WSGGP HAZOP Report

Jemena Western Sydney Green Gas Project

Client Document No: P2G-2099-RP-HZ-002

Document Number	P2G-2099-RP-HZ-002
Revision	1
Code 1 - Issued with No comments	
Mr Tom Breadon - Jemena Asset Management Sep 4, 2020, 11:07 AM GMT+10:00

DRAWING NO.	REFERENCE DRAWINGS
FG-H03001	FG-H03001-DW-PD-006

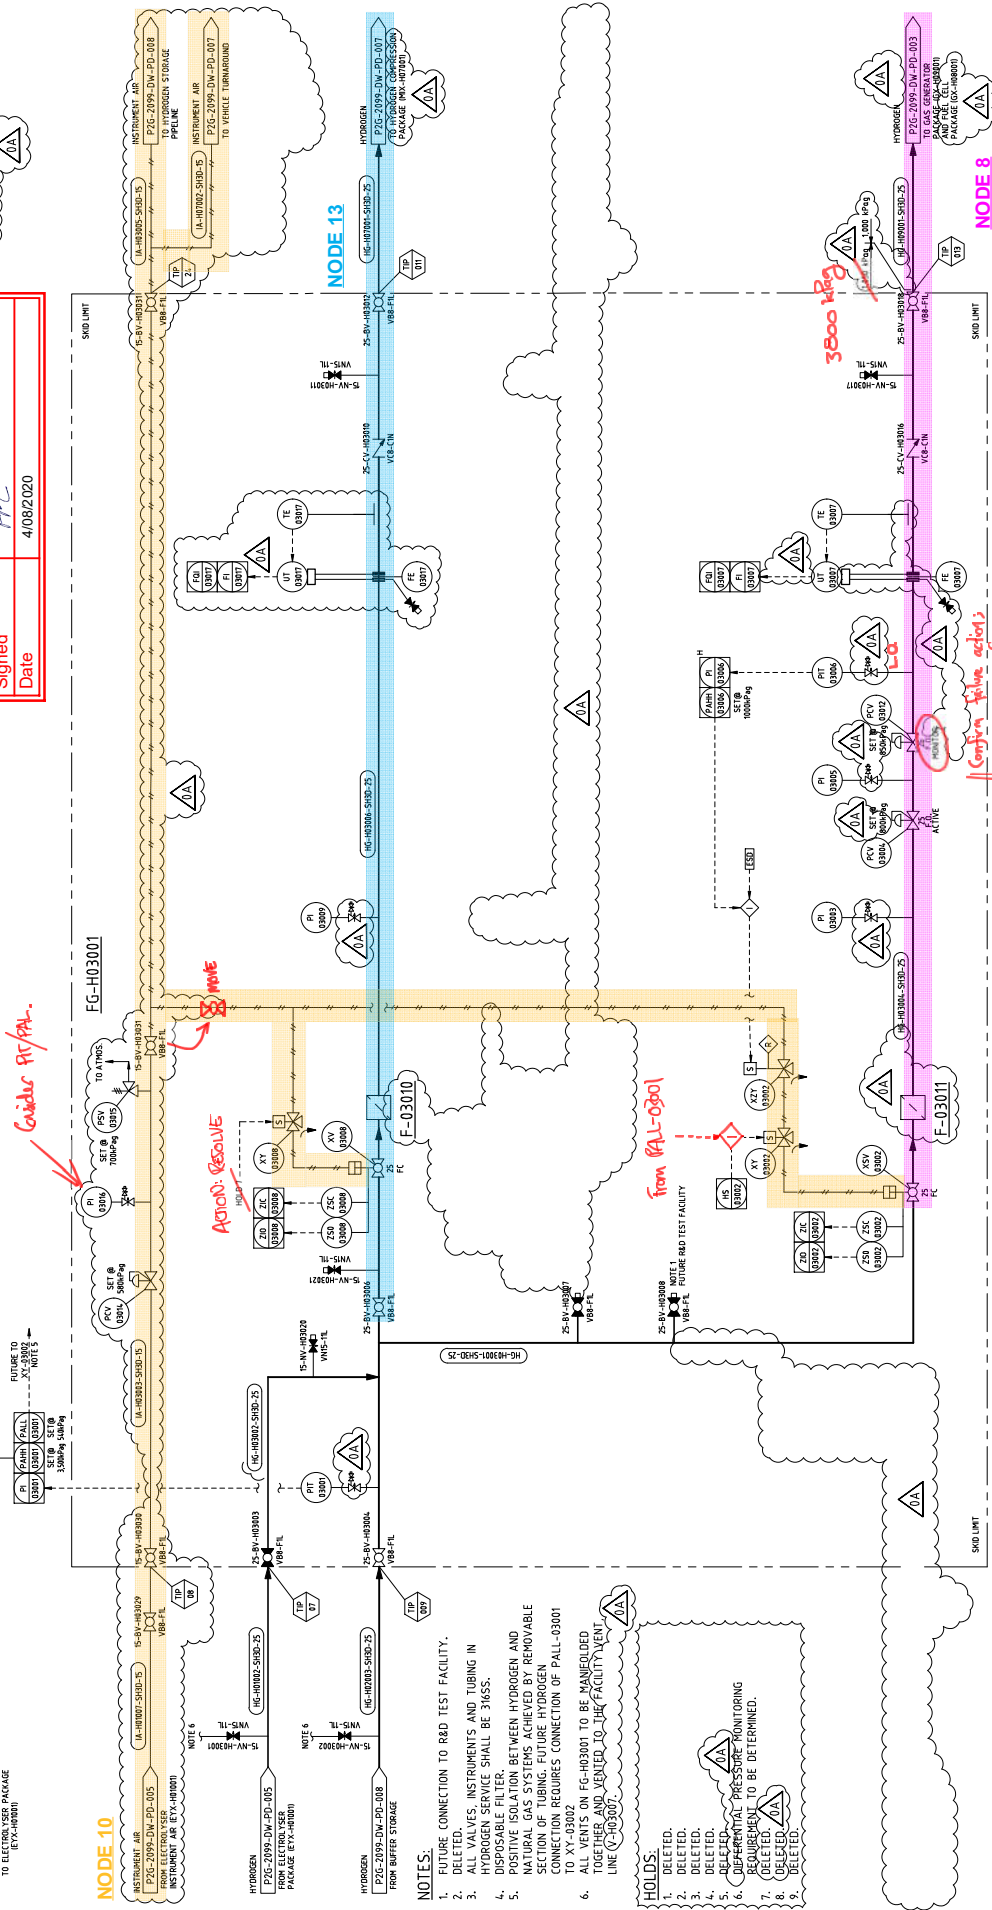
Confirm future action
change to F.C. if
practical. Delete future
action if relevant.

Provide 1/4" NPT sample point.

PROVIDE 1/4" NPT SAMPLE POINT.

DESIGN	SH	SCALE	N.T.S.
CHECKED	MPK	SUPERVISOR	A1
APPROVED	177	DRAWING NUMBER	REV
DATE	25/07/20	BY/APPN	P2G-2099-DW-PD-007

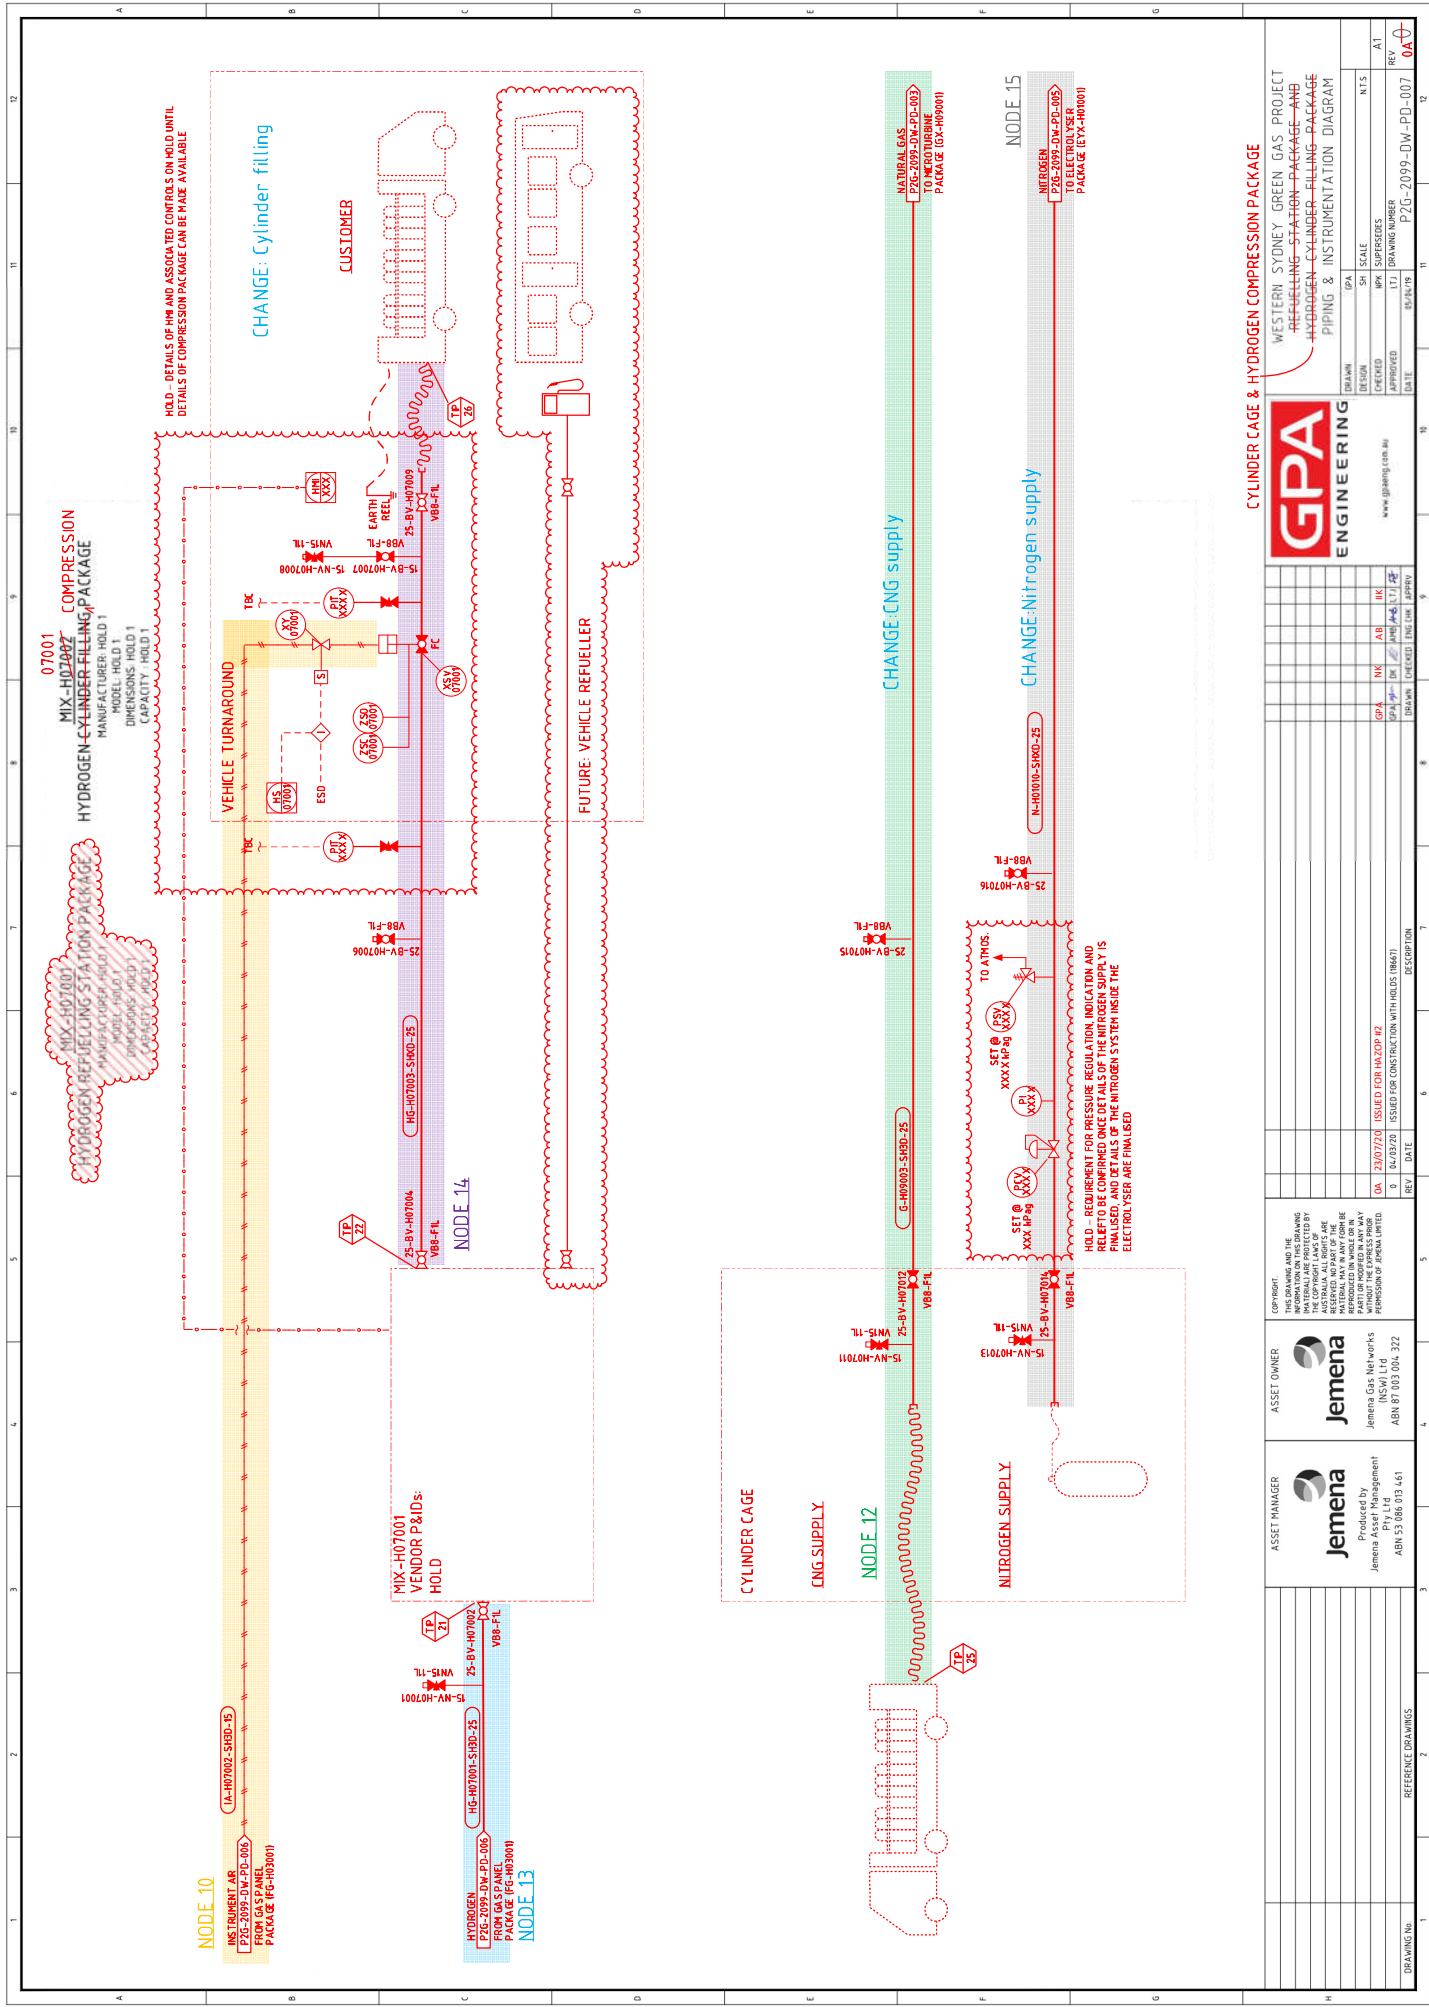
CYLINDER CAGE & HYDROGEN COMPRESSION PACKAGE
